Technical Service Information

FORD E4OD COOLER BYPASS VALVE ADDED TO SOME 1997 MODELS

Figure 1

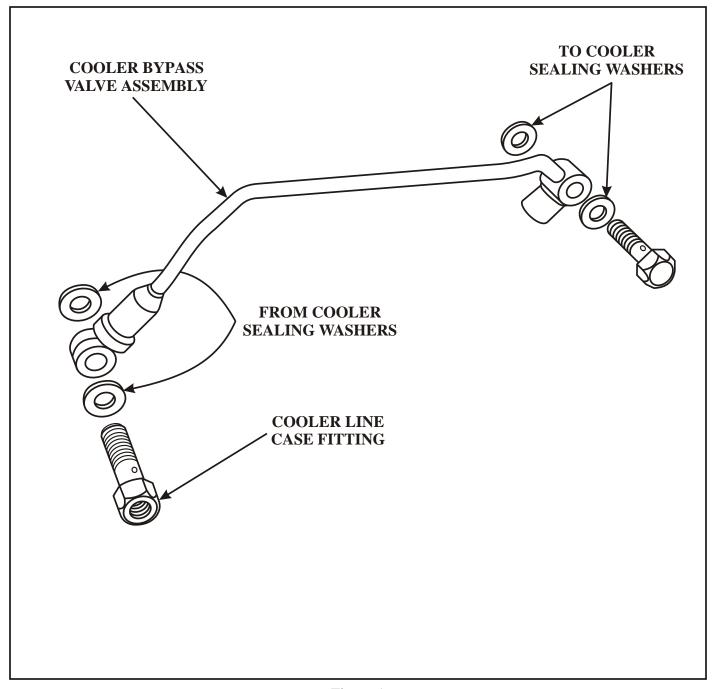
CHANGE: Some 1997 Econoline, Expedition, F-150 Trucks and F-250 Trucks have been equipped with a Cooler Bypass Valve Assembly that requires sealing washers on both the "To Cooler" end and "From Cooler" end of the bypass valve assembly, as shown in Figure 1.

REASON: Increased lube flow during cold weather operation.

- (1) COOLER BYPASS VALVE ASSEMBLY Added between the cooler line fittings in the case, to increase lube flow during cold weather operation (See Figure 1).
- (2) CASE FITTINGS Requires special case fittings to retain the "Banjo" ends of the cooler bypass valve assembly into the transmission case (See Figure 1).
- (3) SEALING WASHERS Requires sealing washers on both of the "Banjo" ends of the cooler bypass valve to seal properly (See Figure 1).

The new design Cooler Bypass Valve Assembly will retro-fit back to all previous models.

If a removed Cooler Bypass Valve has an "O" ring installed, remove the "O" ring prior to reinstalling the assembly. The "O" rings are only used to hold the sealing washers in place for shipping purposes. If the entire Cooler Bypass Valve requires replacement, be sure to remove the shipping caps and "O" rings prior to installation.
